## Appendix C

### Notice of Preparation Comment Letters

**SUBJECT: SINGLE-FAMILY RESIDENCE IN STUDIO CITY – NOTICE OF PREPARTION OF EIR**

Case No: ENV-2014-4031-EIR

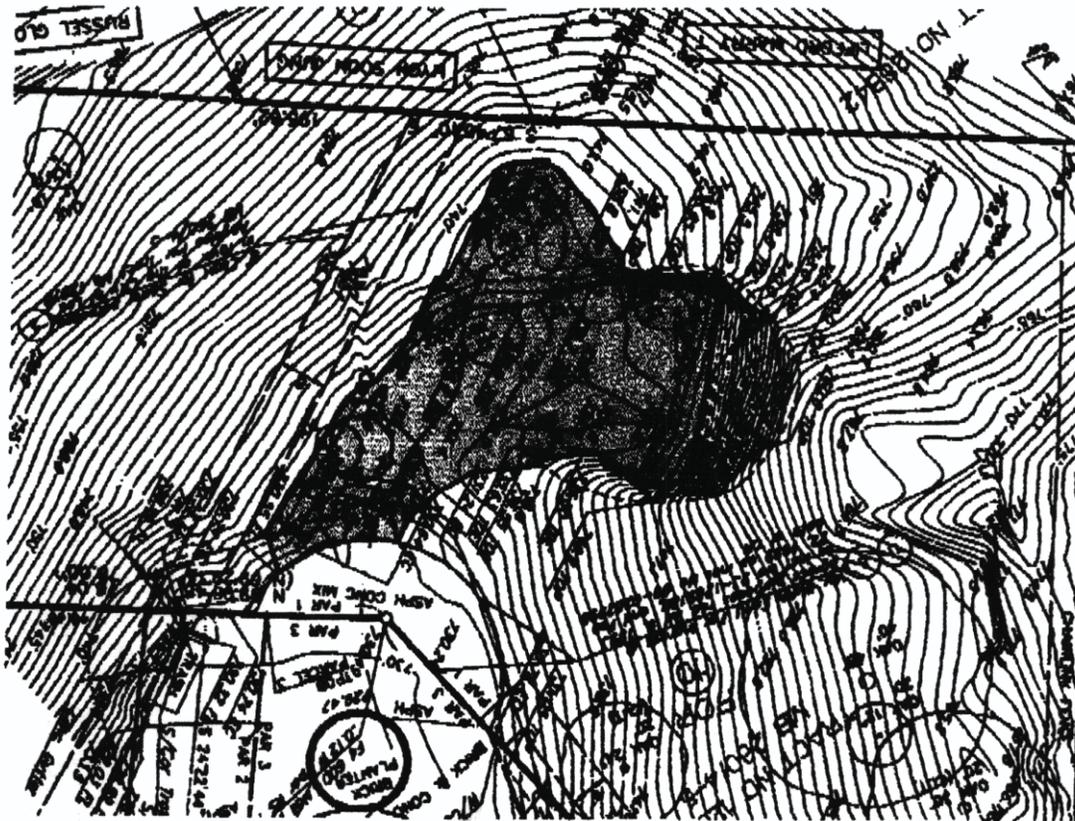
7. Based on the field evidence of the presence of water, soil and weathering patterns indicative of presence of water, and the extent of the Arroyo Willow and Blackberry Riparian plant community, a spatial delineation of the wetland, spring, and stream channel was produced (Figure 1 and 2). The total area designated riparian or wetland on this delineation is about 2350 square feet.

My analysis, based on field investigation of current conditions in the vicinity of the spring, shows that the existing permanently moist riparian habitat at the site totals approximately 2350 ft<sup>2</sup>. Because much of the water emanates from a sandstone outcrop that would be buried under the driveway of the proposed structure, and because this area would be contained by a retaining wall, there is a clear potential that the project would impact this entire riparian area by possibly impeding or cutting off natural flow to it.
